Lower Thames Crossing Community Impacts Consultation 2021

Response from Kent County Council

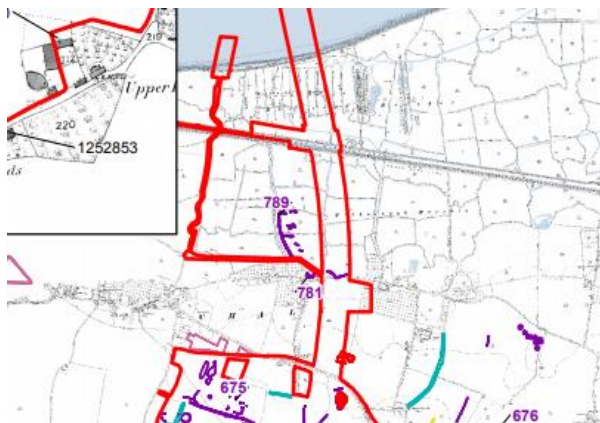
Land east of Thong (WSI parcels 82 and 83) – These parcels would benefit from magnetometry followed by targeted trial trenching, In particular, as these parcels cover a dry valley where ponds are proposed the area of the ponds should be subject to early trial trenching. I recommend at least two trial trenches, orientated west-east across the dry valley, in the area of the proposed ponds. Significant archaeological remains of Palaeolithic, Mesolithic and Neolithic date as well as evidence of more recent activity has been recorded by the 2020 trial trenching within this same dry valley further to the north and buried below hill wash. This archaeological potential needs to be tested to understand the implications of locating ponds in this area east of Thong village (see WSI U).

Land north-east of Thong (WSI parcels 78 and 79) – The 2020 trial trenching results demonstrate that these parcels are likely to have archaeological potential and will include part of the dry valley noted in relation to parcels 82 and 83 (above). It would be helpful if these parcels could be subject to trial trenching this summer and in particular parcel 79 (see WSI U).
